P1 Project Drawing Updates - 10/23/2019

Ferris State University			
DRAWN	BRIAN BRADY	DATE	10/16/2019	TITLE DRILL UNIT MAIN ASSEMBLY DETAILS BALL SCREW SUPPORT BRACKET		
CHECKED						
APPROVED						
MATERIAL STEEL 1020		VOLUME 625418 mm³		SIZE C	DWG NO. BR-549-C-002	REV.
SCALE 1:2		WEIGHT 4.922 kg		SHEET 5 of 20

BR-549-A-002

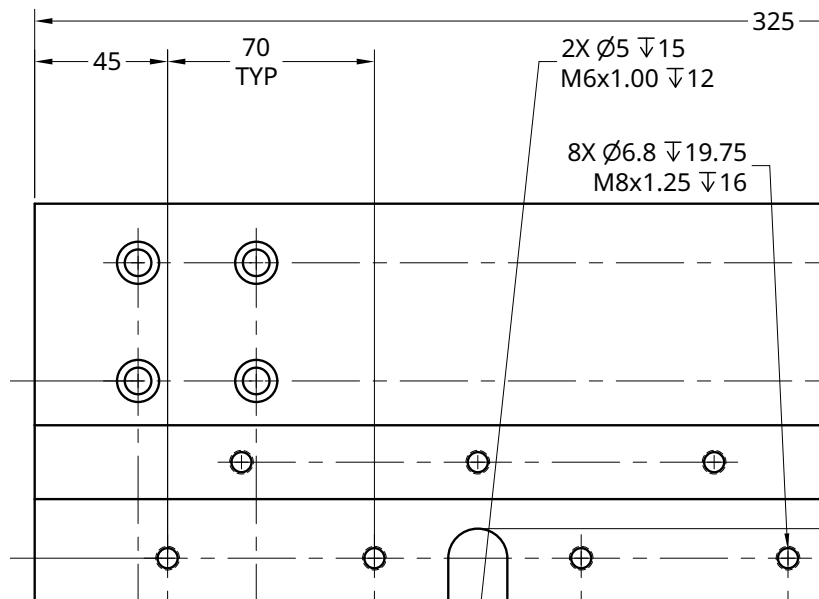
Groove diameter was missing. Also there are 7 (not 6) 0.5 x 45° chamfers.

BR-549-B-001

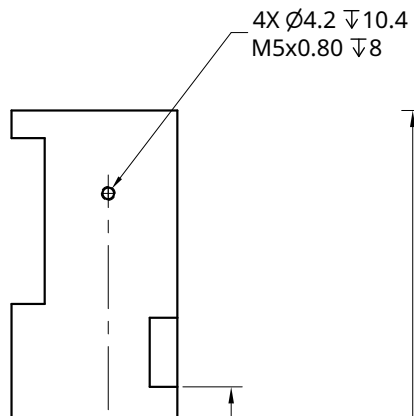
4 holes were missing hole callouts

BR-549-B-006

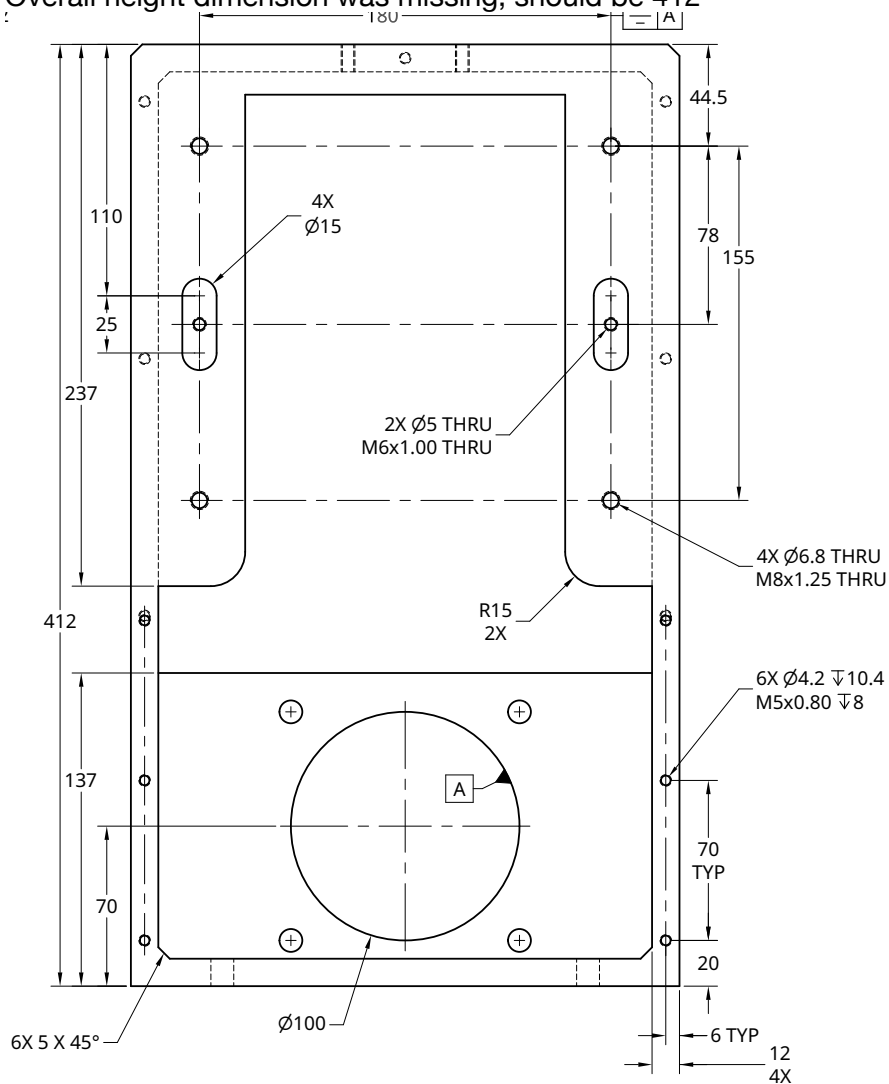
Overall height dimension was missing; should be 412

BR-549-C-001

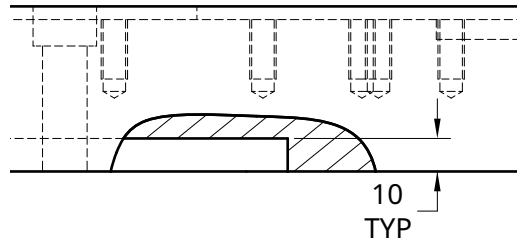
Keyway depth dimension was missing

BR-549-C-003

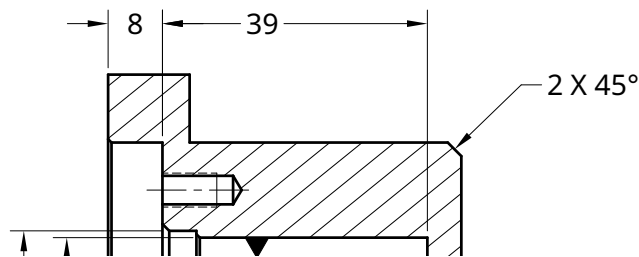
Chamfer dimension was missing

BR-549-C-011

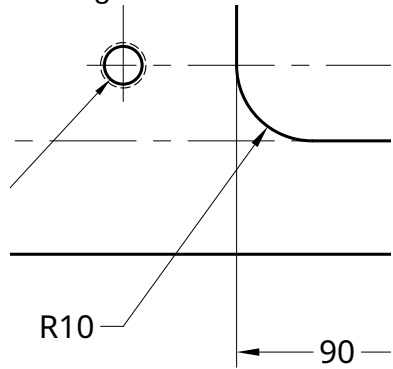
Missing radius dimension
